VALLEY VIEW SUBDIVISION
PREVIOUSLY KNOWN AS BINZ ENGLEMAN SUBDIVISION
MASTER DEVELOPMENT PLAN

October 31, 2005

Re: Valley View Subdivision (Amendment) MDP # 789-A

70' TYPICAL STREET SECTION
SCALE: HORZ. 1"= 10'
VERT. 1"= 5'

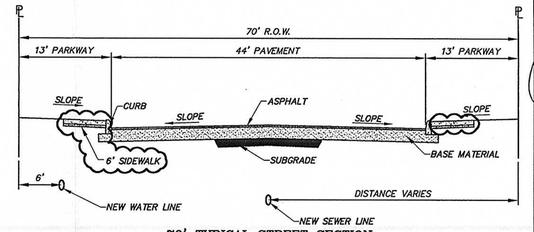
2. Construction of an internal collector street system approximately 1400-feet in length. Collector street design parameters consist of 70 feet of ROW and 44 feet of pavement (Table 506-3). The proposed collector street shall have no houses fronting (UDC 35-515, (c),(4)).

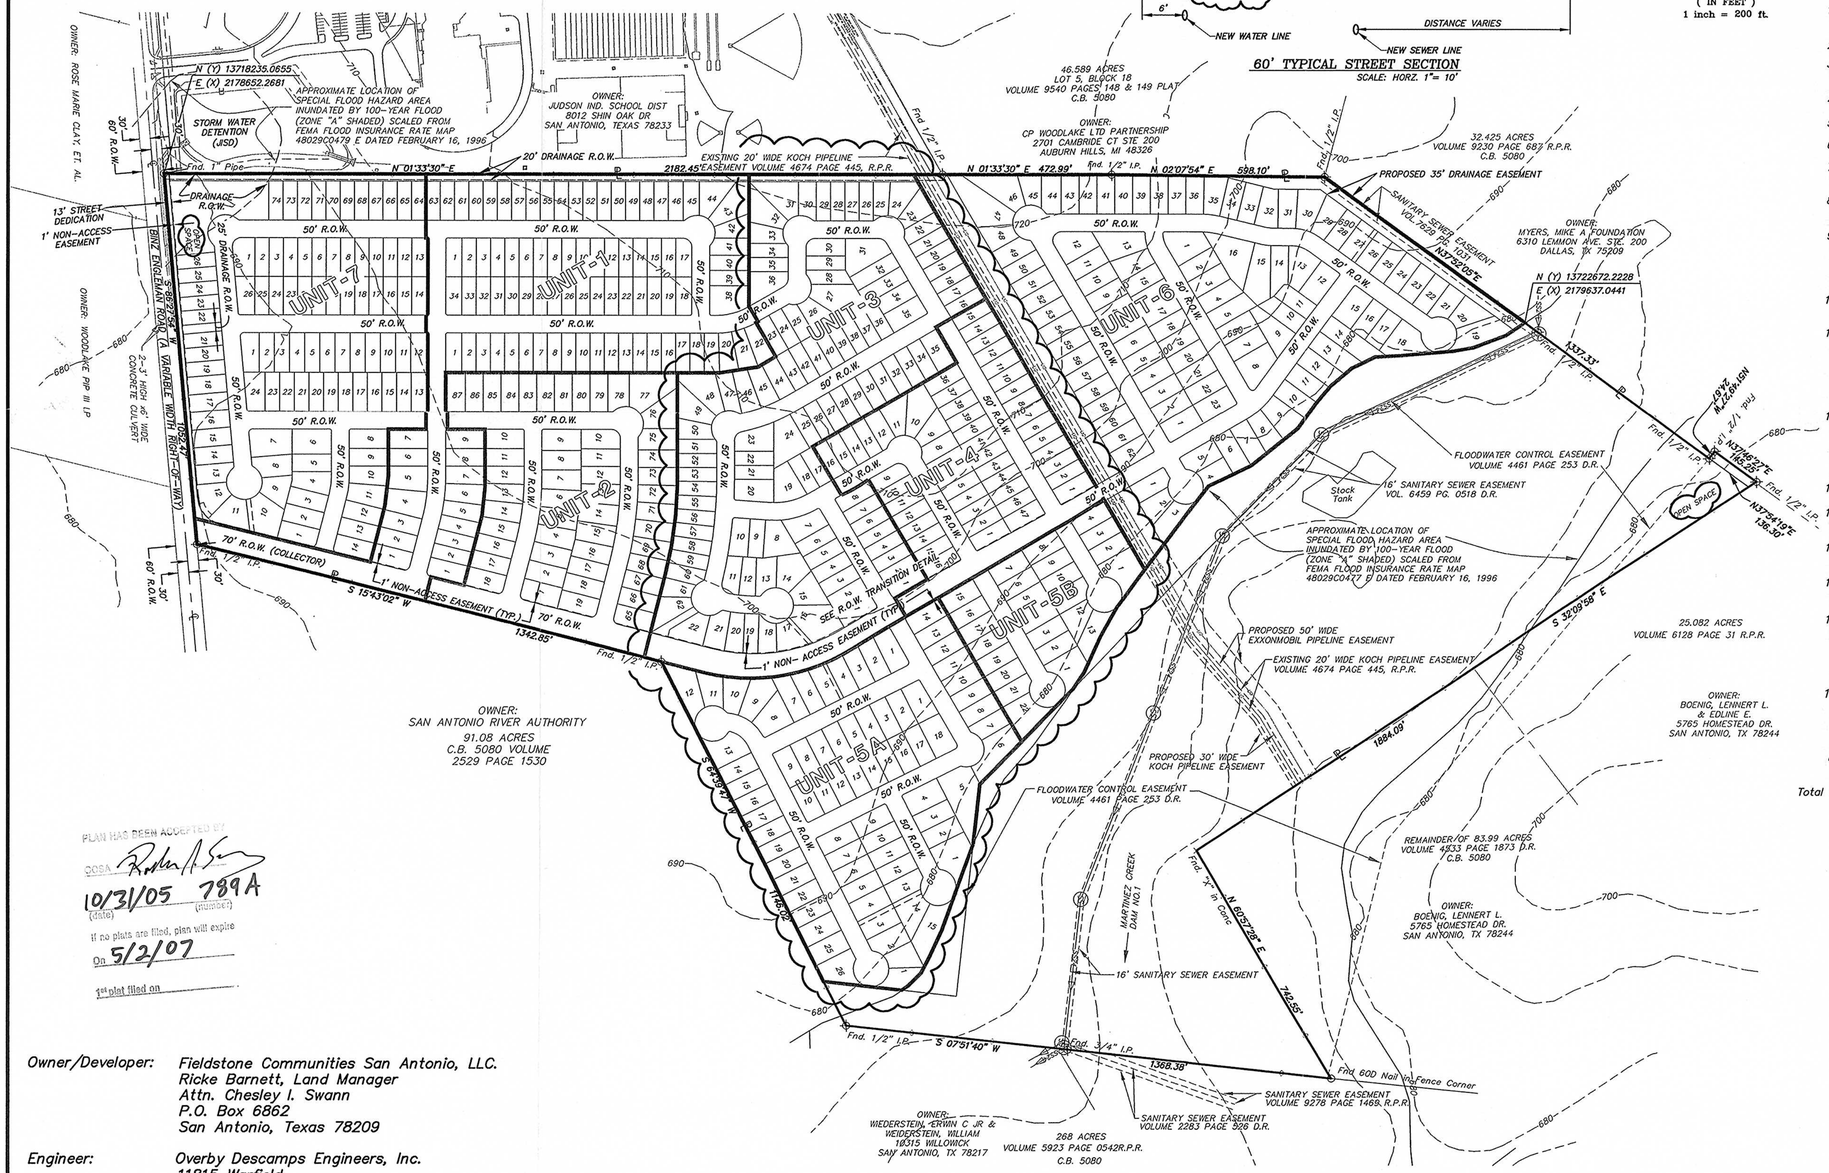
- Development Service Planning as part of the conditional approval, cite at the time of platting Unit-6 shall satisfy this section of the City of San Antonio Unified Development Code (UDC) by the following means:
    1. Provide and construct the street stub-out and drainage culvert in accaordinance with the UDC or
    2. A variance request to section 35-506, (e) Connectivity, (2) Projecting Streets before the Planning Commission.

- Storm Water Engineering as part of their conditional approval cite the following:
  1. Please note that according to Walzem Farms Subdivision drainage study, June 2002, the 100yr ultimate development causes the Martinez Dam Site#1 pool level to rise to an elevation of 676.38. All structures adjacent to the inundated area must be at level two (2) feet above this water surface elevation. The crest of Martinez Dam Site#1 is at an elevation of 680.6 feet.

2. In case a storm event of a higher magnitude hits this general area, the floodplain inundation may cause major flooding in the adjacent areas of the dam. The hydraulic inadequacy of the dam makes it unable to pass the Probable Maximum Flood (PMF). The proposed development will be inundated up to the elevation when the breach occurs and will be above the crest of the dam. Even floods of lesser magnitude, assuming routing starts at the emergency spillway, will also flood the proposed development. The consultant must determine this elevation and routing of the PMF is needed. The engineer can also use the 1981 report done by the US Army COE. Should you have any questions please call at 207-5012.

1. Binz-Engleman Road- The Developer shall dedicate 43 feet of ROW (Ordinance 98282, October 2, 2003 Major Thoroughfare Plan (MTP)) from the centerline of Binz-Englemen Road (Secondary Arterial Type A – Uniform Development Code (UDC) 35-506, (g), (2) adjacent to this proposed project. The total length of property frontage is 1052.47- feet as indicated by submitted MDP.

3. Construction of an internal Local B Street approximately 1200-feet in length from the end of the proposed collector to Unit 6 (UDC Appendix A, Definitions of Local A and Local B).

4. All Roadways shall conform to UDC 35-506(c), (1), Table 506-1: Functional Classification System Description.
  5. The developer shall be responsible for upgrading the intersection of Binz-Engleman Road and the Collector Street. This includes a sufficient left-turn storage lane on eastbound Binz-Englemen Road, with a bay taper and transition (UDC-35-506,(m),(2) and a right-turn deceleration lane (westbound Binz-Engleman Road) with a storage lane and bay taper as it relates to the submitted TIA traffic counts, (UDC –35-502 (a)(7), subsection C.
